Three Mile Island Nuclear Station, Unit 1
Renewed Facility Operating License No. DPR-50
NRC Docket No. 50-289

Subject: Response to Request for Additional Information - Relief Request RR-11-01
and RR-11-02

Response to Request for Additional Information - Relief Requests RR-11-01 and RR-11-02

Figure 1
NDE Data Report Coverage Plot for Welds RCH0001ASG0003N and RCH0001ASG0004N.

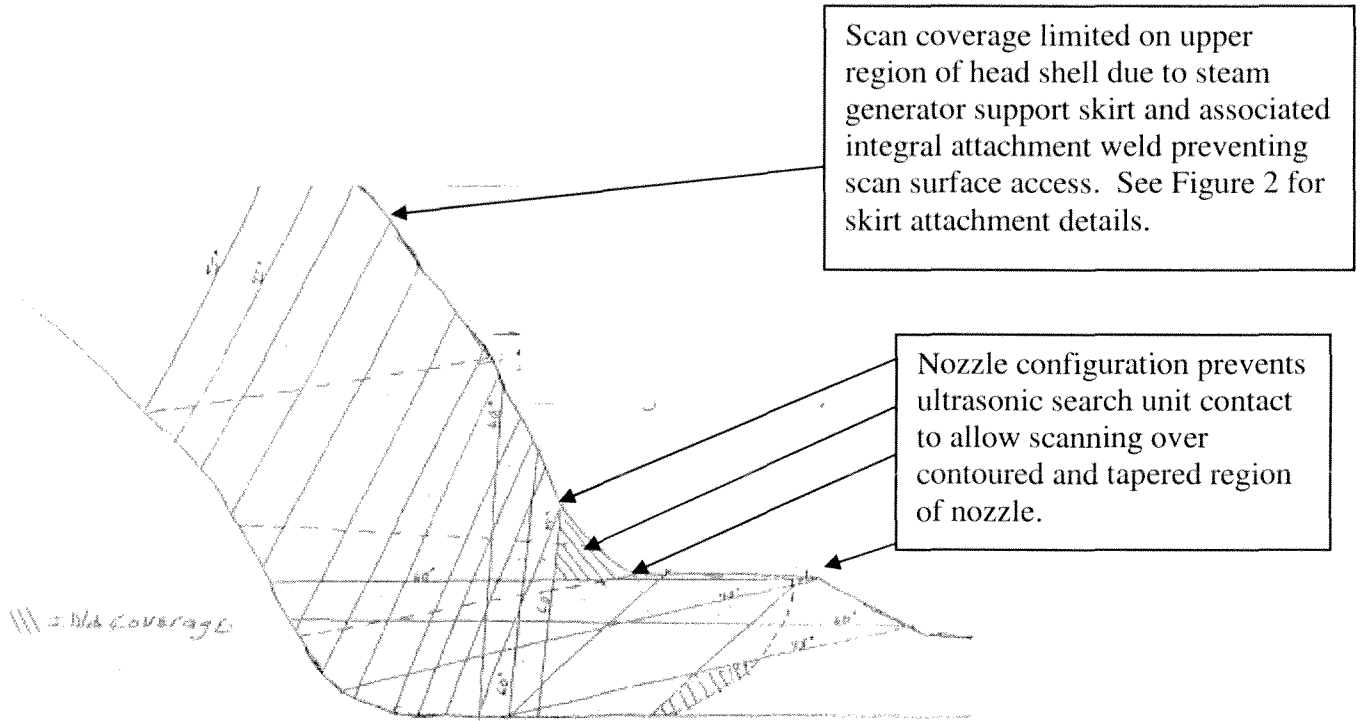
1. Describe the specific limitations for each item as to why 100% of the required inspection volume cannot be examined, i.e., what configuration, interference or other reason prevented 100% ultrasonic examination coverage of the item in question?

Figure 1 below is a duplication of Figure 1 from Relief Request RR-11-01 with annotations noting the examination limitations due to the nozzle configuration. Figure 2 below provides a steam generator lower head configuration that includes the steam generator support skirt attachment that limited examination coverage from the head shell (applicable to welds RCH0001ASG0003N, RCH0001ASG0004N, RCH0001BSG0008N, and RCH0001BSG0009N).

Note that welds RCH0001BSG0008N and RCH0001BSG0009N are identical in design.

Figure 6
Valve to Safe End Valve Configuration

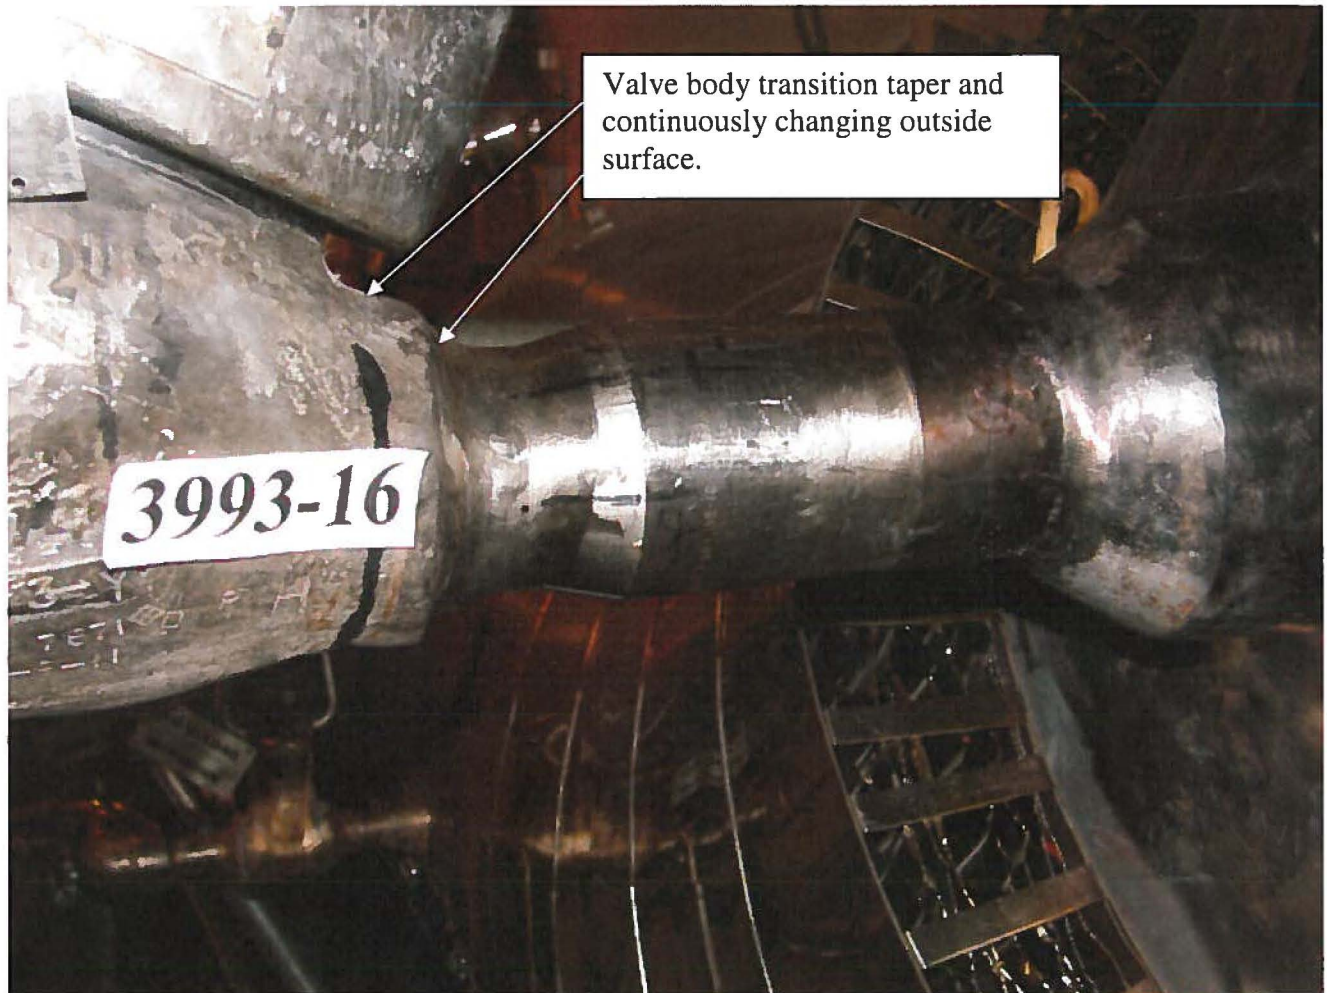
1. The submittal states that due to valve geometry, code coverage is limited to 50%. Please describe Exelon's best effort attempt to achieve maximum coverage in/through the cast austenitic stainless steel portion of these welds.

2. A pre-replacement typical valve to safe-end configuration was provided. Has the configuration changed post-replacement?

While not PDI qualified for detection of flaws on the far side of an austenitic weld, the 70° shear wave examination interrogates the far side of the weld along with a lower adjacent segment of the Cast Austenitic Stainless Steel (CASS) valve body. There are no additional ultrasonic examination methods beyond the techniques described that will provide meaningful and reliable examination results. The valve body is constructed of A351-CF8M material (CASS) for which there are no ASME Section XI, Appendix VIII / Performance Demonstration Initiative qualified examination techniques. Current UT examination techniques have not demonstrated reliable performance in CASS material due to sound attenuation. The valve configuration has a tapered transition at the edge of the weld and a continuously changing outside surface contour which limits ultrasonic search unit contact (see Figure 6 below).

There is no change to the valve configuration. The safe-end design, however, was modified to move the safe-end outside surface taper further away from the valve to allow full examination coverage of the safe-end side of the weld including adjacent base material. The removed safe-end did not provide adequate surface area for UT examination on the safe-end side of the weld. This resulted in the pre-service examination coverage improvement when compared to the original configuration.
